# **Intel<sup>®</sup> Ethernet Controller I210**

**Specification Update**

***May 2017***

Revision 2.3  
332763-007

**Figure 1-1 Explanation of Top Markings for A3 Stepping**

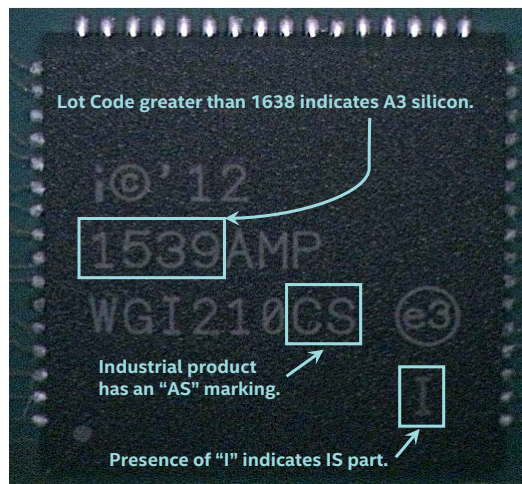
The A3 stepping only applies to the Fiber (IS/CS) products. The A3 stepping can be identified by the Fab Lot Trace Code marking on the package or by the iNVM contents.

- Fab Lot Trace Codes starting with 1638 or greater are A3 devices.
- Bit 1 of INVM\_DATA[61] (0x12214) is 1b on A3 devices.
